Rezoning Transportation Analysis

Petition Number: 2020-161

General Location Identifier: Tax ID 03327114

Date	Description
12-28-2020	First Review (EL)
1-21-2021	Second Review (EL)

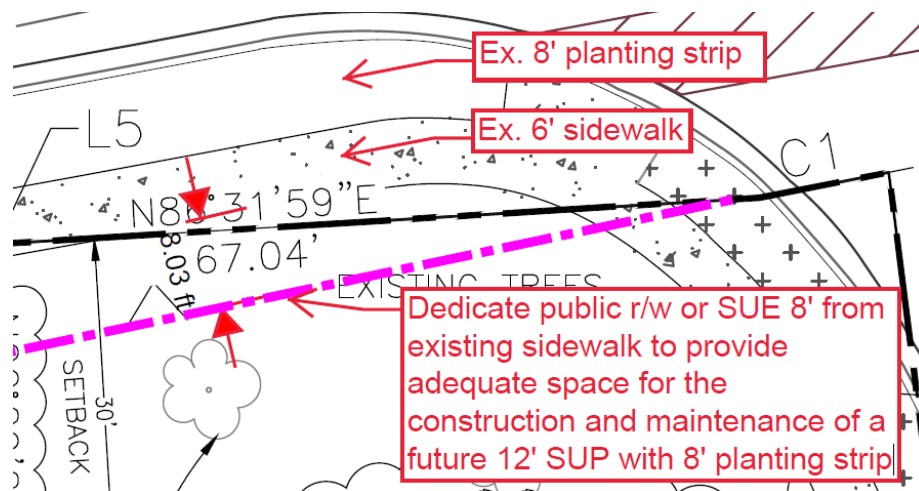
7. **Technical Clarification** (site plan dated 1-10-21) Revise the site plan and conditional note (Section Transportation.E.) to dedicate public right-of-way or a sidewalk utility easement at the location below.
